# Proposed ResCode Deemed to Comply provisions

**Banyule City Council Submission – September 2024**

# Appendix A: Officer feedback in response to proposed changes to Clause 55

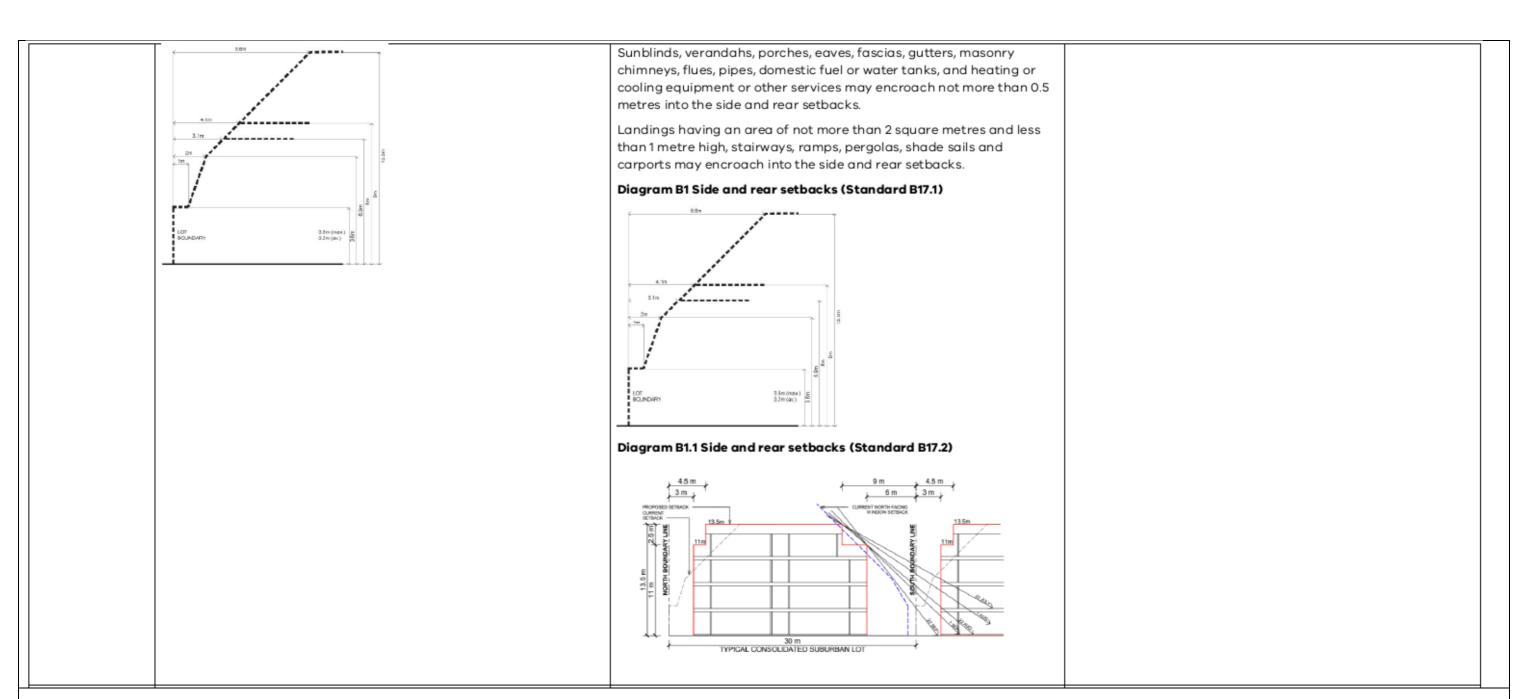
**Officer Comments:** This change is opposed. It is unclear why two standards are proposed and how the new standard B17.2 has been developed. Whilst there is some merit to a separate setback standard for four storey developments, the application of B17.2 to two and three storey buildings, reduces the existing setback requirements under B17.1 at the upper levels to the detriment of adjoining properties.
